ROCKY FLATS PLANT
EMD RFI/RI WORK PLAN OU-6
WALNUT CREEK PRIORITY
DRAINAGE

CONTROLLED DOCUMENT ENVIRONMENTAL MANAGEMENT
EG&G - ROCKY FLATS PLANT
ENVIRONMENTAL MANAGEMENT DOCUMENT CHANGE NOTICE (DCN)

Title Site Characterization	Date 1-29-93	DCN Number 21100-WP-OU6.01 93.0148
Expires 1-29-94	Procedure Revision Required <input type="checkbox"/> Yes <input checked="" type="checkbox"/> No	
Scope Limitation None

Title	Field Sampling Plan	Date	1-29-93	DCN Number	21100-WP-OU6.01 93.02
Expires	1-29-94	Procedure Revision Required	<input type="checkbox"/> Yes <input checked="" type="checkbox"/> No		
Scope Limitation	None

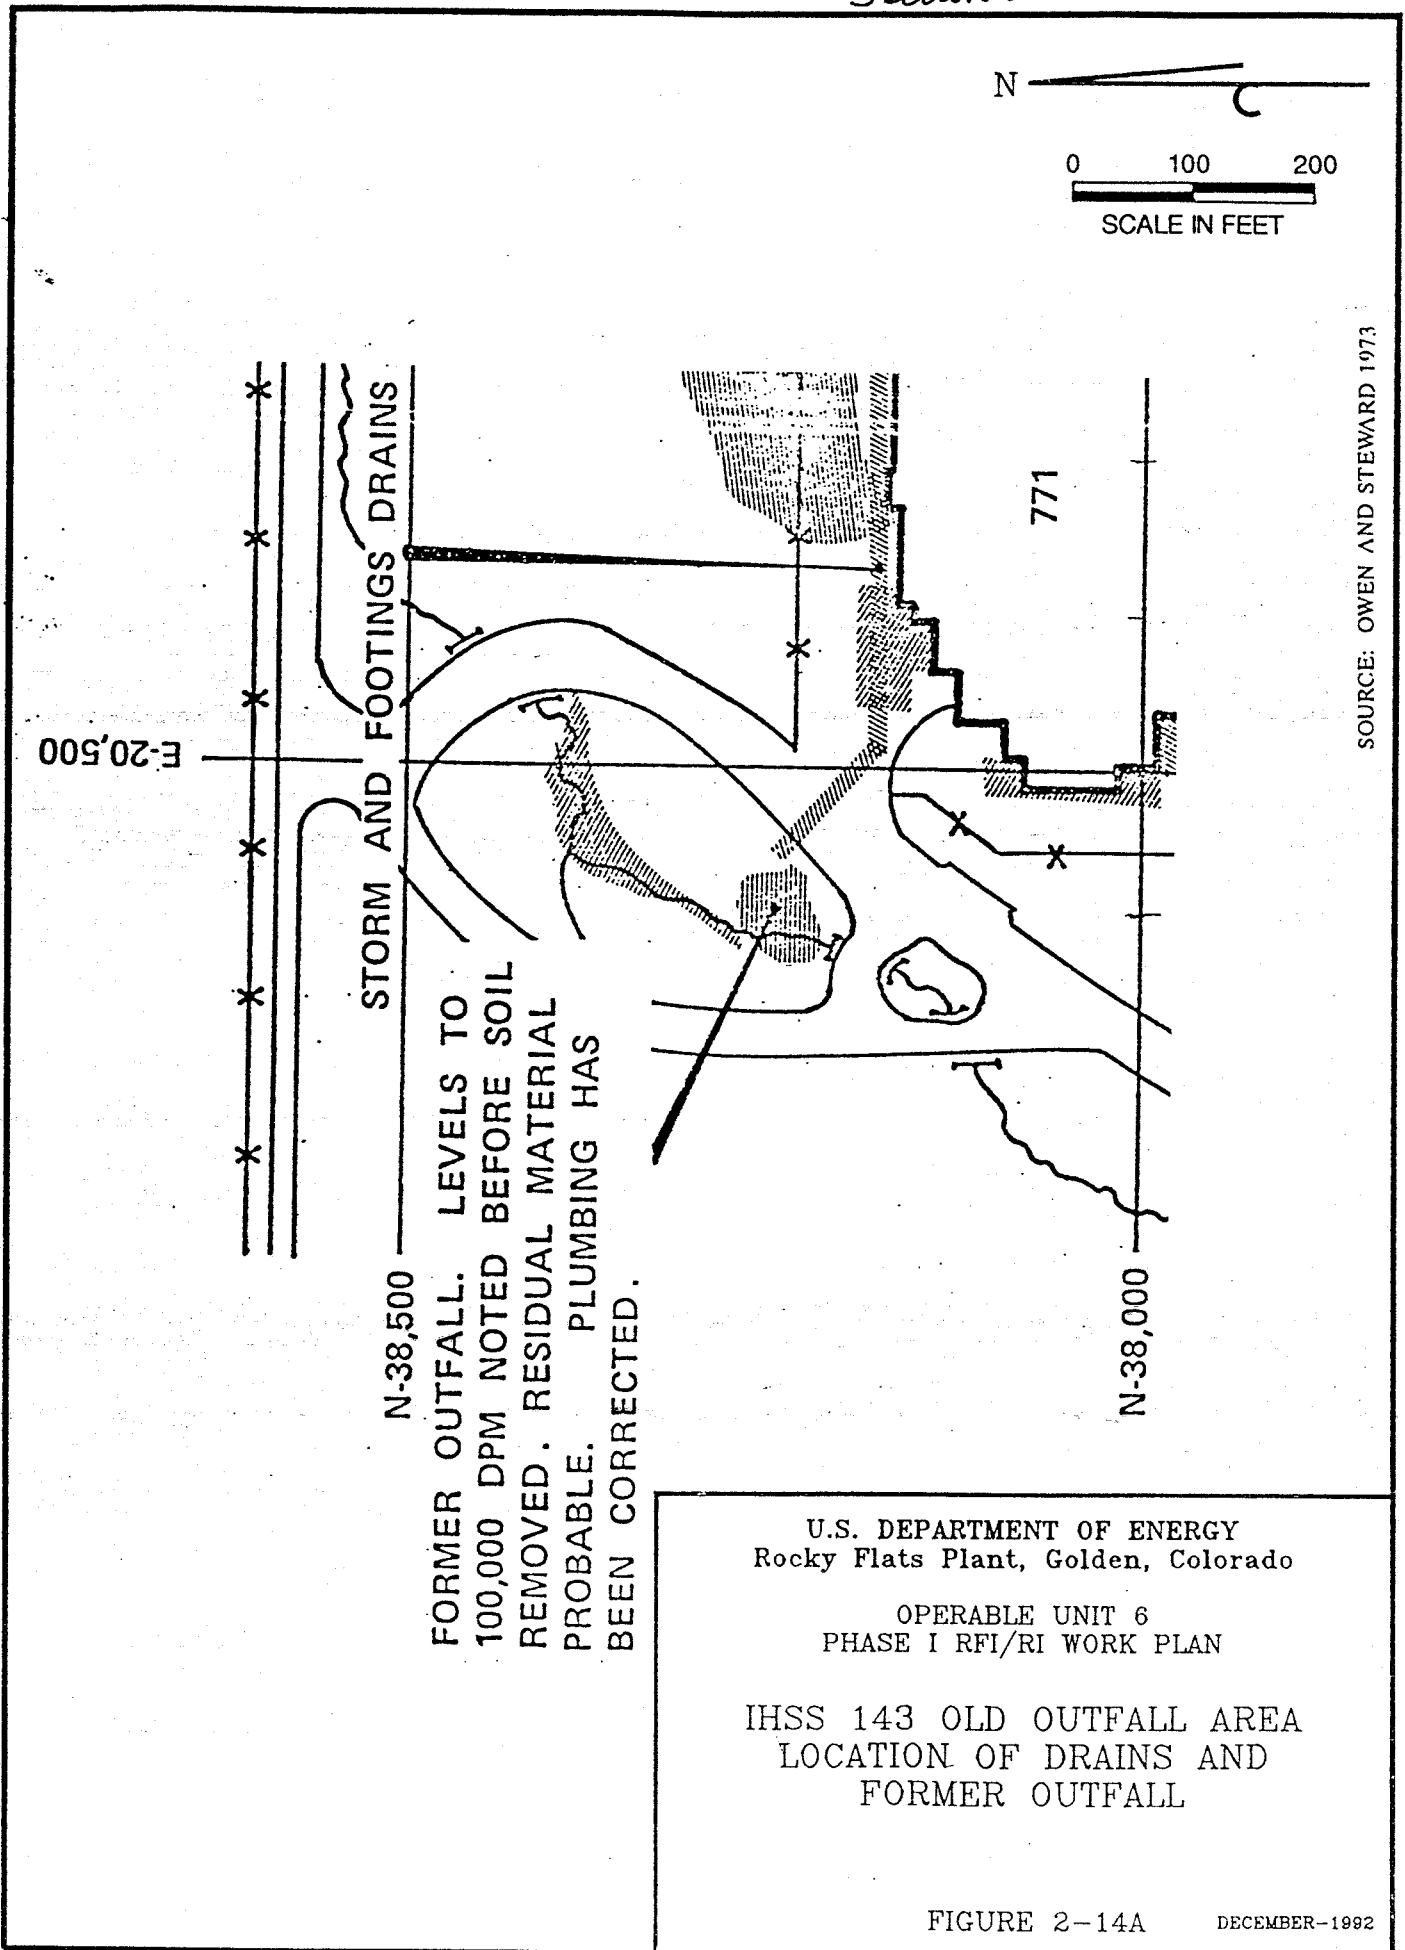
Item Number	Page	Step or Paragraph	Changes (Use DCN CONTINUATION SHEET for Additional Space)
1	2/64	2.9.1, Par. 1	Add "and Figure 2-14A" with the parentheses at the end of the paragraph 1/28/93
2	2/64	2.9.2, Par. 4	Add "(Figure 2-14A)" at the end of the fourth sentence in the paragraph.
3	2/66	Figure 2-14	Add Figure 2-14A following Figure 2-14.
4	2/67	2.9.3, Par. 1	Add "and Figure 2-14A" within the parentheses at the end of the paragraph. 1/28/93

Additional references to IHSS 143 have been reviewed again during stage 1 activities of the Field Sampling Plan. The additional map is provided in Section 2.0 (items 1-4) to show an additional representation of the geometry of the IHSS.
